**City of West Linn**  
**PRE-APPLICATION CONFERENCE MEETING**  
**August 20, 2009**

**SUBJECT:** Lot line adjustment, replat or partition to reconfigure three existing lots. Proposal would maintain the same number of lots at the Tannler East site.

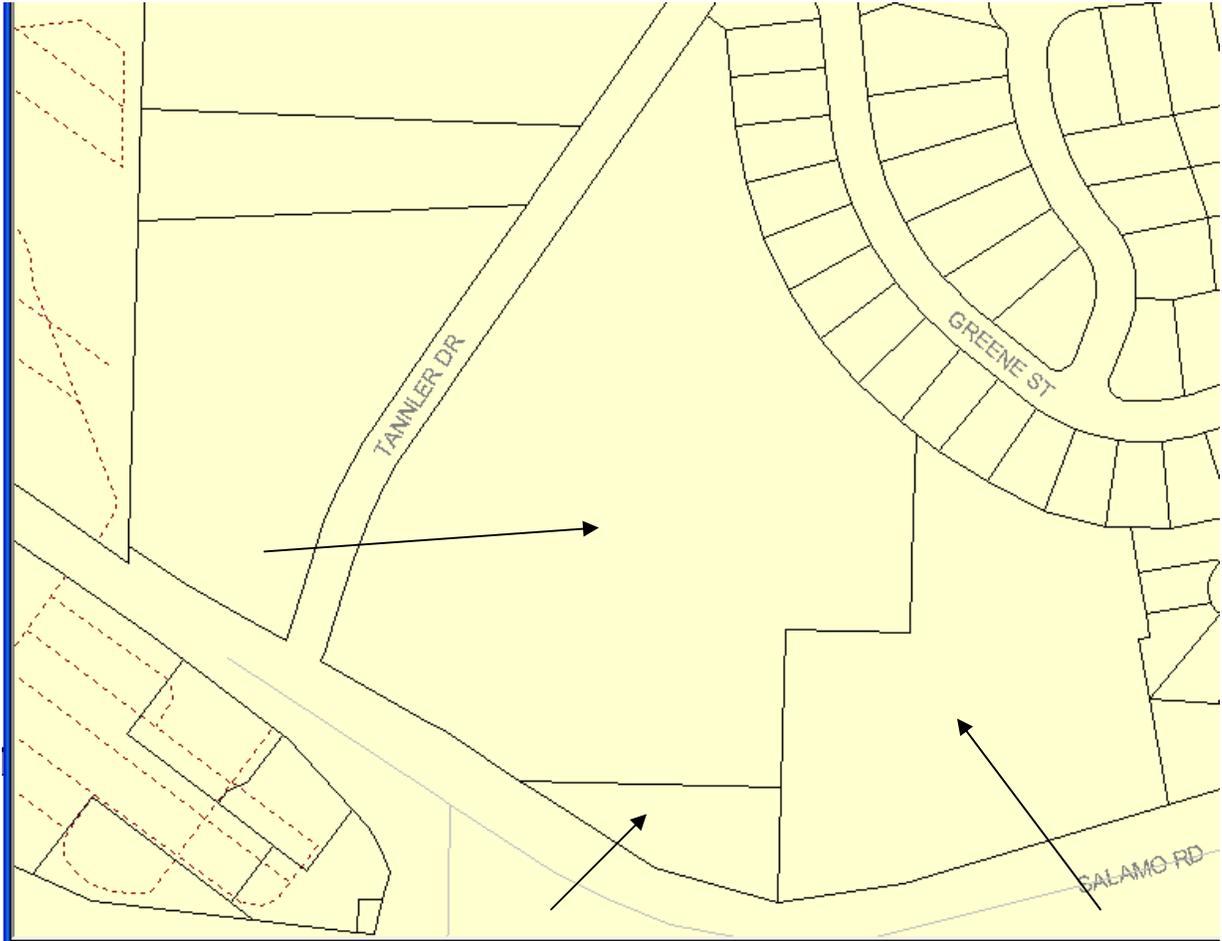
The hillside is already divided into three parcels but the shape of these lots does not correspond with the plans listed in the previous paragraph. The applicant is proposing to reconfigure those lots to accommodate these plans by one of three options: (1) lot line adjustment, (2) replat, or (3) minor partition.

The central question to be answered is which of the three methods: lot line adjustment, replatting or partition is appropriate?

Whereas staff was initially concerned that this proposal would not qualify as a LLA, House Bill 3629 was passed in March 2008 and allows more comprehensive adjustments of lot lines. Combining that with the fact that the southern lot is not created as a habitable lot (where dimensional standards have purpose and rationale behind them), the southern lot is only being formed for resource protection. Therefore staff can endorse the LLA proposal.

Per CDC 99.038 a neighborhood meeting would be required with the Savannah Oaks Neighborhood Association. The applicant would however still run into the same problem that lot C violates the shape and dimensional standards for lots in the OBC zone. Minimum lot width is 35 feet and minimum lot depth is 90 feet. A Class II Variance would be required.

(Area shown in pink is area not part of acquisition by City)

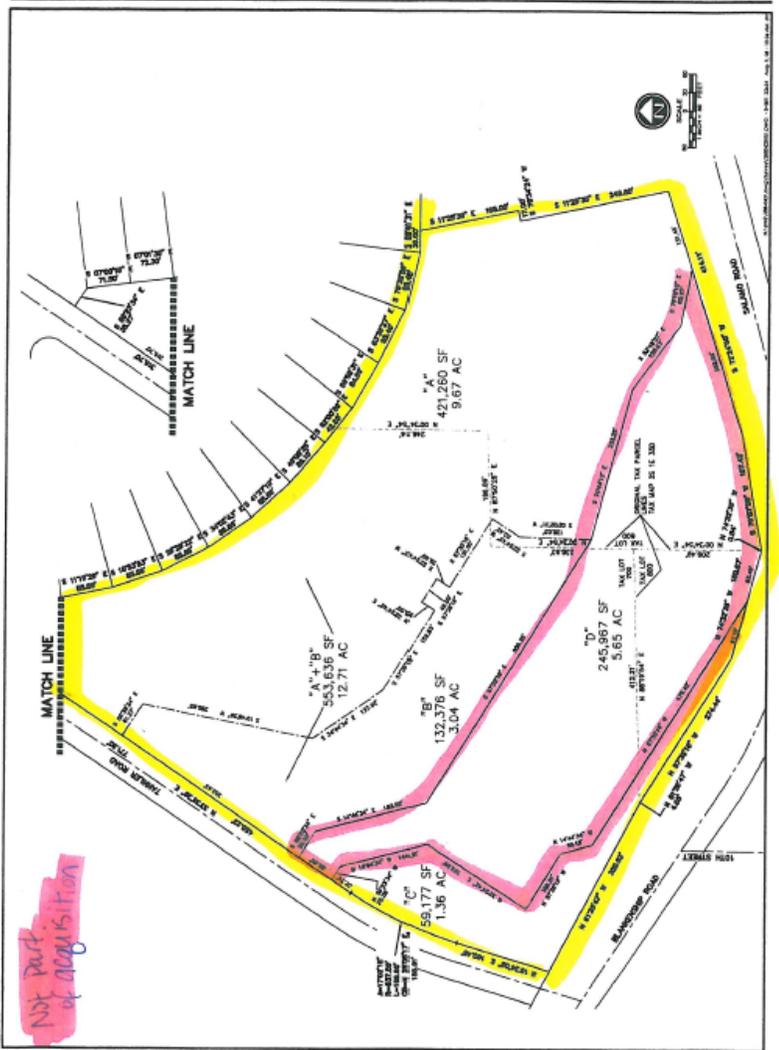
The applicant has negotiated with the City of West Linn to sell the northern portion of the hillside property known as “Tannler East” to the City as an open space area in order to preserve a unique white oak savannah. The applicant would also sell the City a narrow strip of land at the southern edge of the hillside adjacent to Blankenship Road to protect additional significant oak trees. The portion of the hillside in the middle would be retained by the applicant for commercial purposes such as a fitness club.
